UNITED STATES PATENT AND TRADEMARK OFFICE

Office Action Summary	Application No. 10/002,985	Applicant(s) ROUSE ET AL.	
	Examiner William H. Rodriguez	Art Unit 3746

DETAILED ACTION

FIG. 1

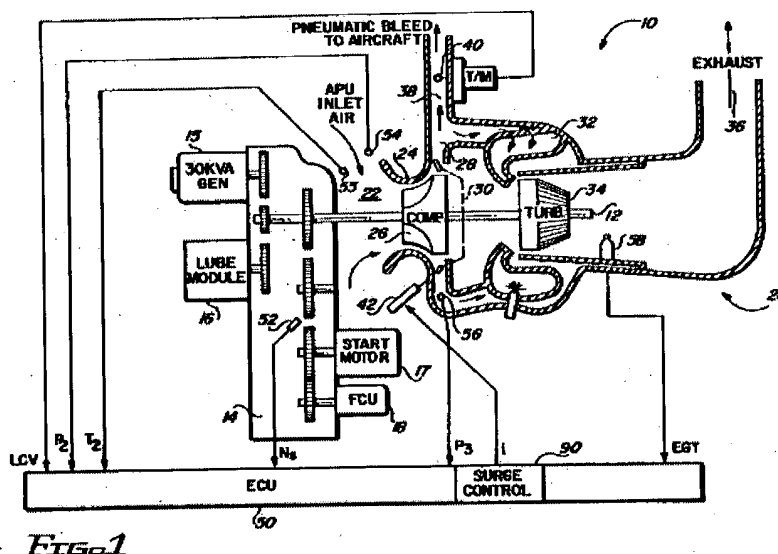
With respect to claim 15, **Evenson et al.** teach a system, comprising: a turbine 34 driven by hot gas; a combustor 32 for combusting fuel and compressed air to generate the hot gas; an air compressor 24 rotationally coupled to the turbine 34 to provide the compressed air; a bleed valve 40 connected to the compressor discharge to vent a selectable portion of the compressed air while the system speed is between a predetermined lower surge line and a predetermined upper surge line to prevent the compressor from stalling; and a controller 50 for controlling

system speed N_s to provide a required amount of power, controlling the bleed valve 40 to maintain a required airflow through the turbine inlet, and controlling the turbine exit temperature EGT to a temperature exhaust value derived as a function of system speed N_s and ambient conditions P_2 , T_2 . See particularly **Figure 1**, column 3 line 20-22, and column 3 lines 39-54 of Evenson.

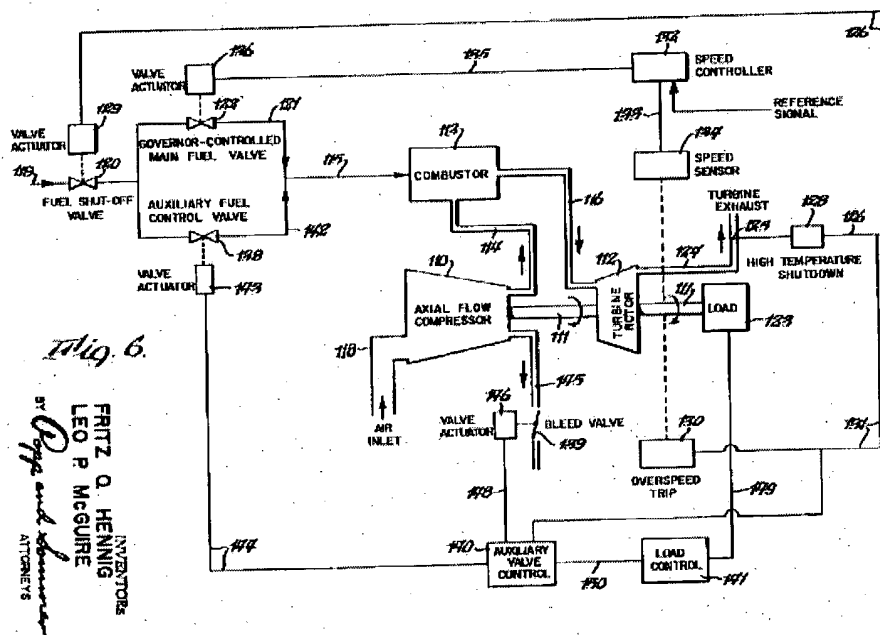
With respect to claim 15, **Henning et al.** teach a system, comprising: a turbine 112 driven by hot gas; a combustor 113 for combusting fuel and compressed air to generate the hot gas; an air compressor 110 rotationally coupled to the turbine 112 to provide the compressed air; a bleed valve 139 connected to the compressor discharge to vent a selectable portion of the compressed air; and a controller 140, 132 for controlling system speed to provide a required amount of

power, controlling the bleed valve 139 to maintain a required airflow through the turbine inlet, and controlling the turbine exit temperature TET to a temperature exhaust value derived as a function of system speed. **Henning** does not mention that the bleed-off of air is done to prevent or eliminate compressor surge or that the temperature exhaust value is derived as a function of ambient conditions. However, it is well known in the art that bleeding-off air from the compressor prevents surge from happening so indirectly Henning's bleed valve 139 prevents the compressor from stalling. Further, **Anand et al.** teach that low ambient conditions lead to compressor surge. Thus, although **Henning** does not mention controlling ambient conditions to prevent a compressor surge, ~~Therefore~~, it would have been obvious to one of ordinary skill in the art at the time the invention was made to have included a controller that monitors ambient conditions since these could lead to a surge compressor. See particularly **Figure 6** of Henning, and column 4 line 20-24 of Anand.
